From: Bunnow, Kyle
Sent: Wednesday, November 06, 2019 9:29 AM
To: Bailey, Heather
Subject: FW: 121 Langdon St
Attachments: IMG_8891.JPG; IMG_8892.JPG; IMG_8881.JPG; IMG_8883.JPG; IMG_8888.JPG; Langdon St 121.pdf

The site plan for 121 Langdon Street has not been implemented as of 11/5/19. Below is an itemized list of elements not completed or needing correction / installation. Attached are photos showing the current conditions and the approved site plan that is being referenced (pages C1 and C2 are the site plan)

John Suhr Residence - EXTERIOR REPAIRS
121 LANGDON STREET, MADISON, WI 53703

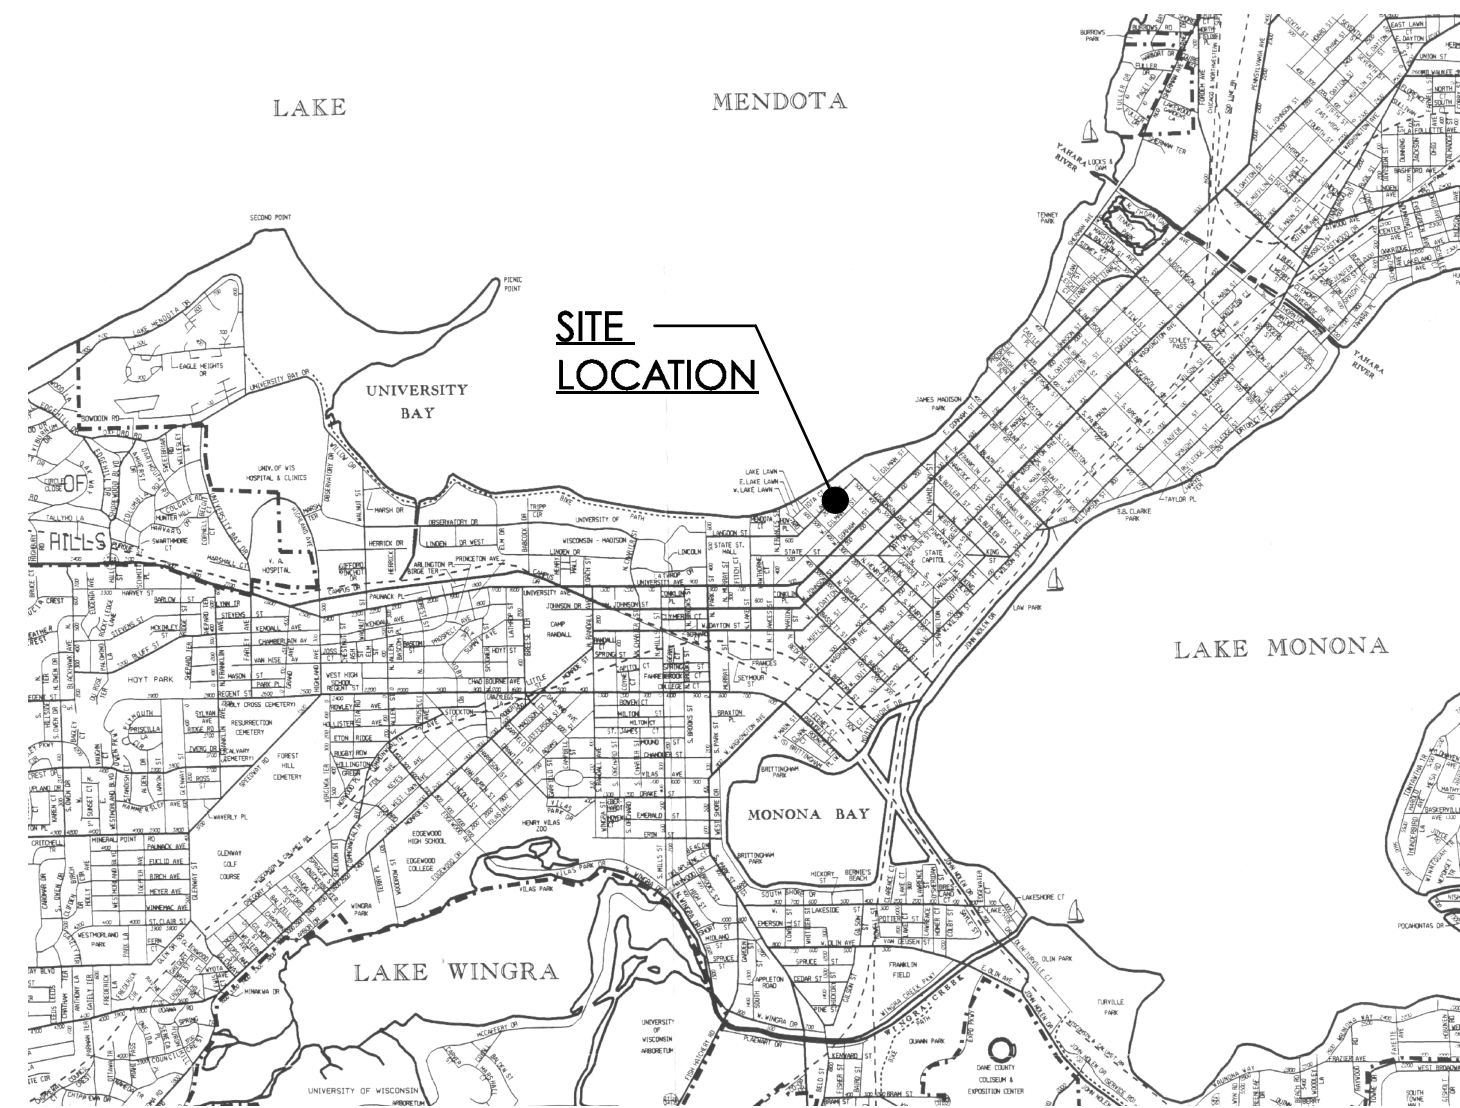
1. Nearly all of the landscaping was missing.
2. Cars were parked outside of designated areas, including in the front yard and alongside the house in required landscaped areas.
3. Aside from a small portion of the site which was newly paved, most of the lot was mud/gravel.
4. Nearly all of the parking lot striping was missing.
5. The required curb stops were missing.
6. The handicap parking sign did not meet state requirements.
